1EW03 - Enabling Works Central

AWHd – Fieldwork Change Control Form A for Archaeological Monitoring at Three Bears Cottage, Grim's Ditch, South Heath Cutting, Buckinghamshire FCCFA033

Document no.: 1EW03-FUS-EV-FRM-CS03_CL05-000020

Appendix 1 -Site location (Map also used in DRN 1EW03-FUS-EV-NTE-CS03_CL05- 000029)

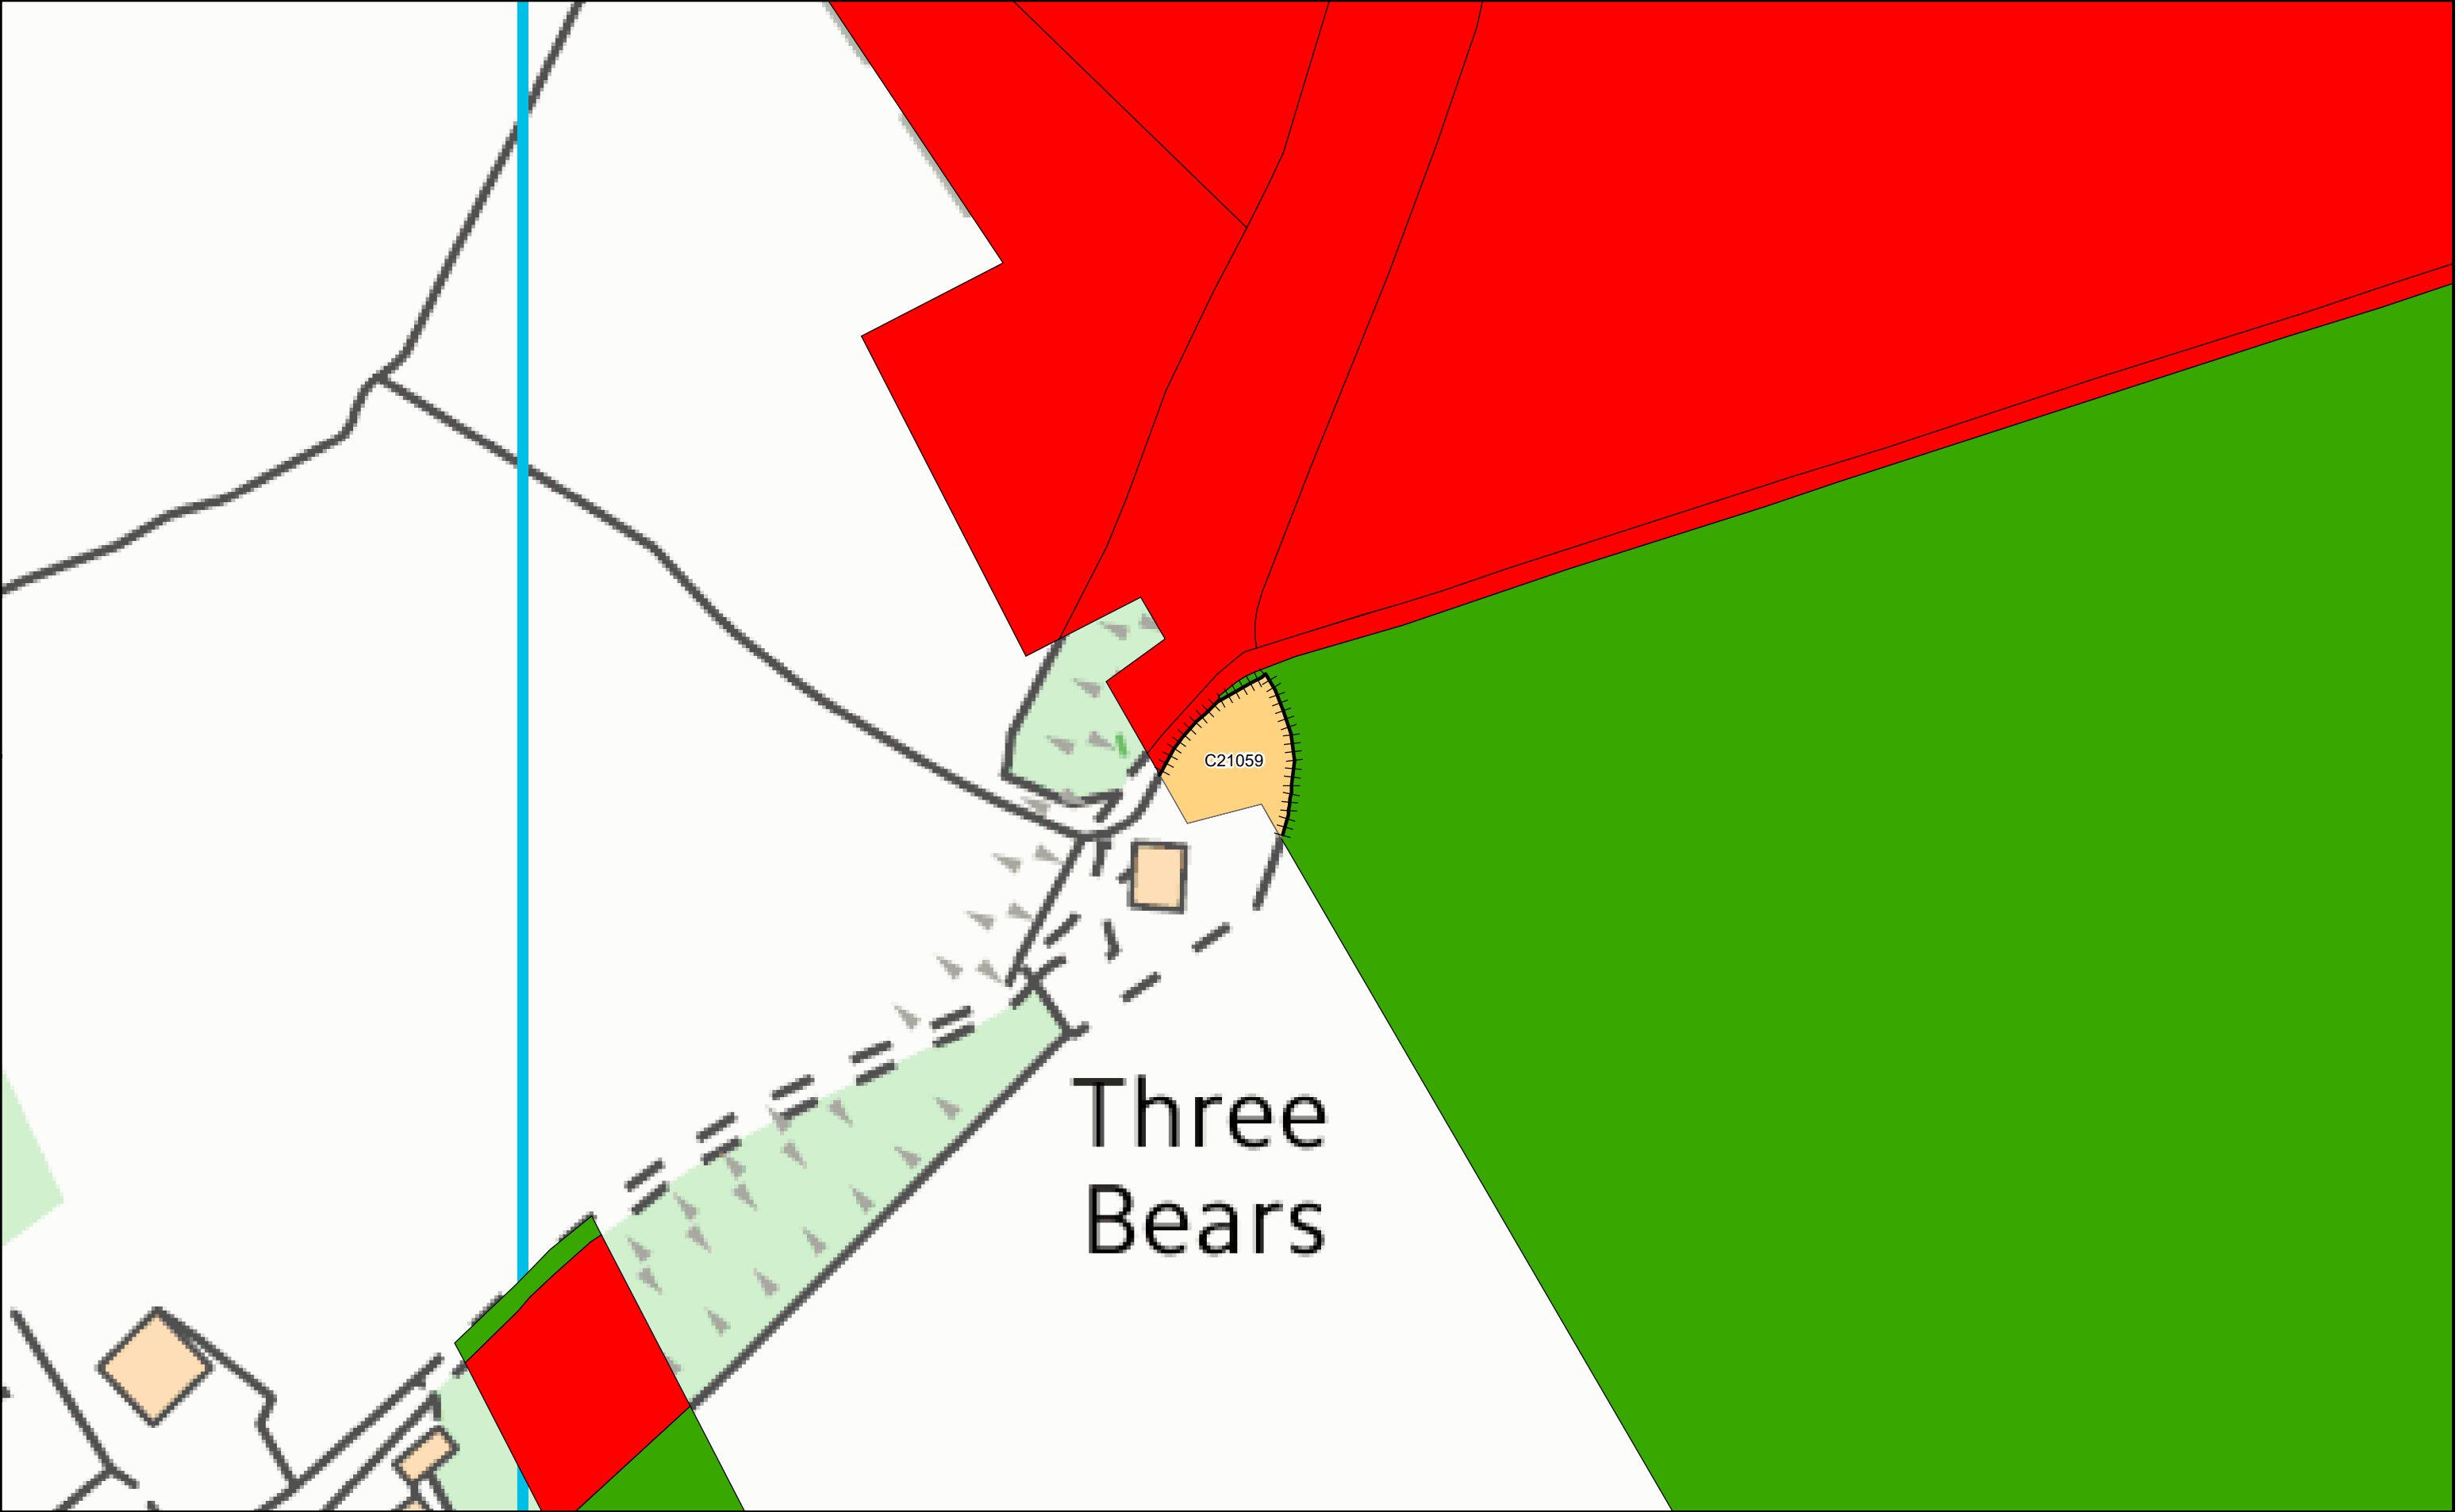
Fusion are required to fence adjacent to the landowners existing fence which is not a suitable boundary for site works. This encroaches in to the Grim's Ditch Scheduled Monument protection zone, but is located to the south of a currently existing trackway. The intrusion consists of one gate within the Scheduled Zone, and one fence post within the 5m buffer zone.

In order to secure the trackway, there is a gate required, with a gate post located on the north side of the trackway. Under the Fusion land access agreements, we are required to provide an access route for the landowner, and a gate is the only way to secure the boundary, while still providing the access route which is required under the license.

Because of the above, it is not possible to relocate the fencing, so new fencing will need to be installed within the Grim's Ditch Scheduled Monument protection zone. Care has been taken to minimise the impact where possible, with the fence being installed by hand to a depth of 600mm. The diameter of the holes will only be sufficient to accommodate the fence posts – approximately 20cm or less. Due to the area being within the scheduled monument zone, it was agreed with stakeholders and HS2 that archaeological monitoring would provide an appropriate response.

Archaeological monitoring of the excavation of 21no. fence posts measuring c.20cm in diameter by 60cm in depth.
